**Re: Final Engineering Review
Earth Removal Application
182 Plympton Street
ADE Project #2518.31**

**Re: *Initial Engineering Review
Earth Removal Application
182 Plympton Street
ADE Project #2518.31***

Subject: RM Thomas Excavating- 182 Plympton Street-Earth Removal Permit Review

Re: Project Plan, 182 Plympton Street, Middleborough, MA

LEVEL SPREADER EMERGENCY OUTLET
NOT TO SCALE

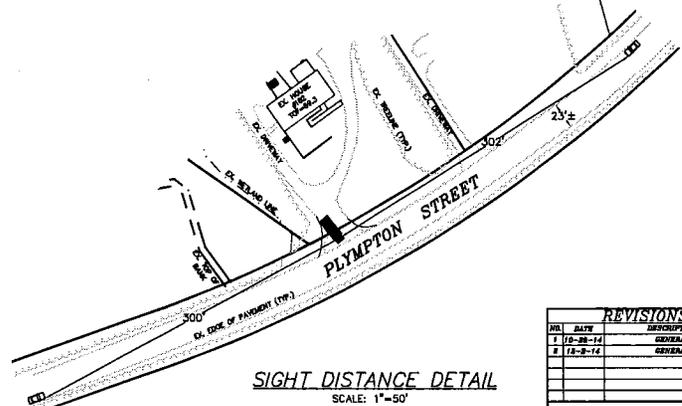
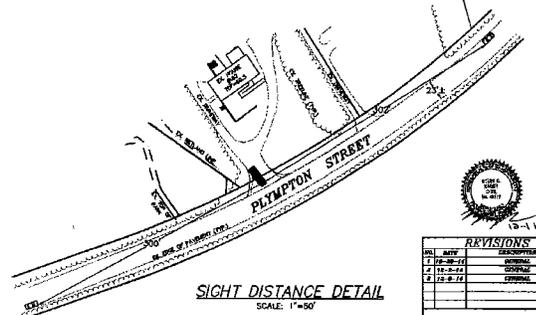
13. Provide more detail of the level spreader outlet. (Rip-rap size, length, width, depth, elevations, etc.). The concern is that there is insufficient room to construct everything outside at the 25-foot no work zone.

GEOTEXTILE EROSION CONTROL BLANKET
NOT TO SCALE

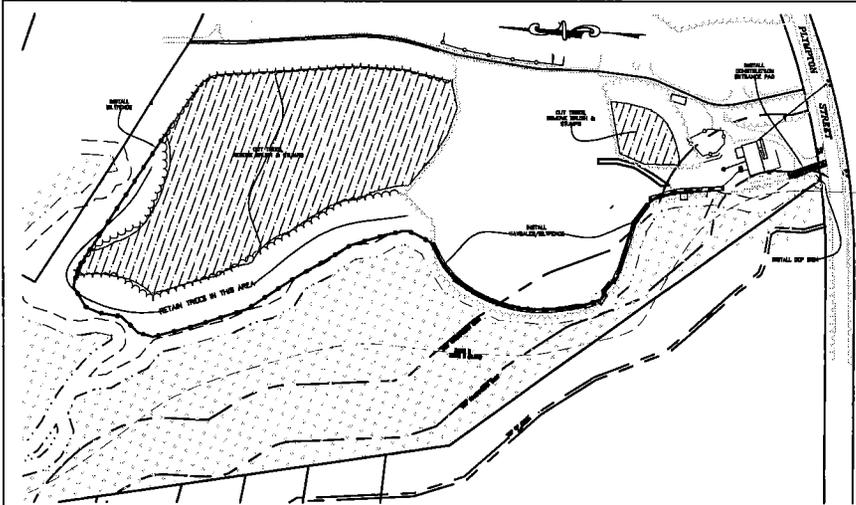
11. The erosion control blanket detail should specify for use on all slopes steeper than 3:1.
 12. Provide a detail for the sheet vinyl piling and clarify its purpose.

- h. Sloping is proposed to be at 2:1 and 3:1 as depicted on the site plans. Areas greater than 3:1 shall be stabilized with the erosion control blanket as shown on the detail of the site plans.

CONSTRUCTION SEQUENCE FOR CRANBERRY BOGS AT 182 PLYMPTON STREET IN MIDDLEBOROUGH, MASSACHUSETTS

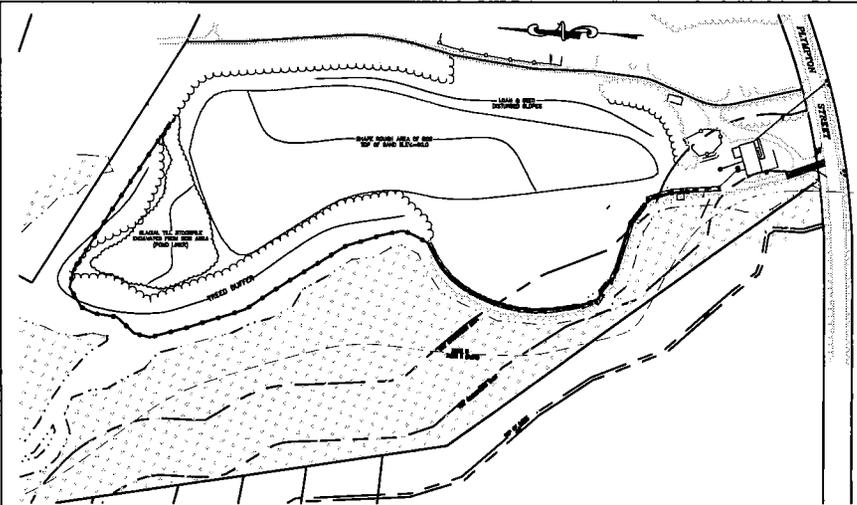
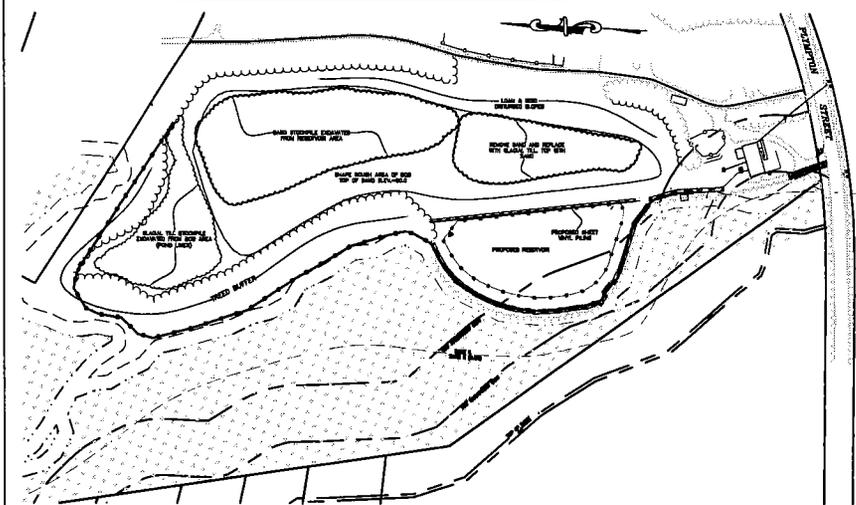
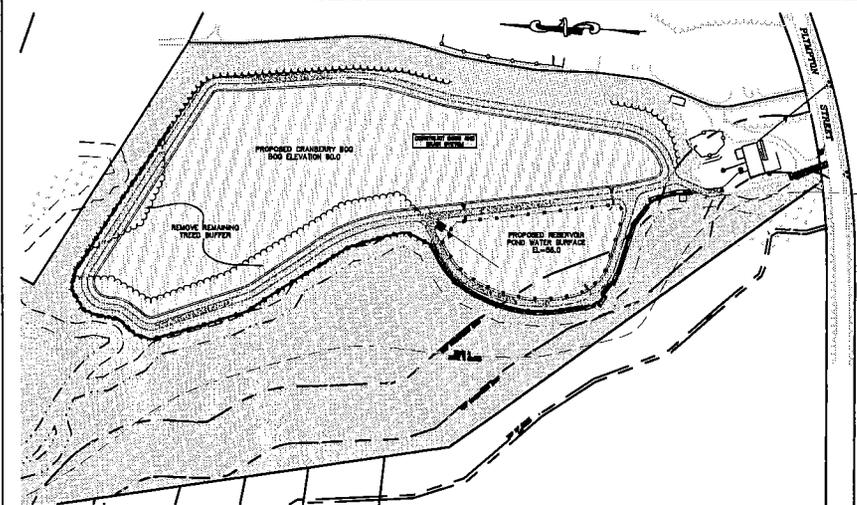
4. The anticipated truck trips per day is not provided. It should be estimated for each phase of the project construction along with a timeline for each phase.

5. **How project will be constructed with phases and time lines provided:** Please refer to Sheet 4 of 4 of the project plans for the detailed construction sequencing process, which is described in 4 phases. **Phase 1:** Generally consists of clearing of the area for the construction of the cranberry bog and placement of the erosion control measures. This phase is estimated to take approximately 6 months to complete. **Phase 2:** Generally consists of shaping of the cranberry bog and loaming and seeding to stabilize the disturbed areas. This phase is estimated to take approximately 6 months. **Phase 3:** Generally consists of constructing the pond and removal of the majority of the material off-site. This phase is estimated to take approximately 1 year. **Phase 4:** Generally consists of the remaining bog to be cleared and constructed. Construct access driveways, pump house, control structures and plant the bog. This phase is estimated to take approximately 1 year.
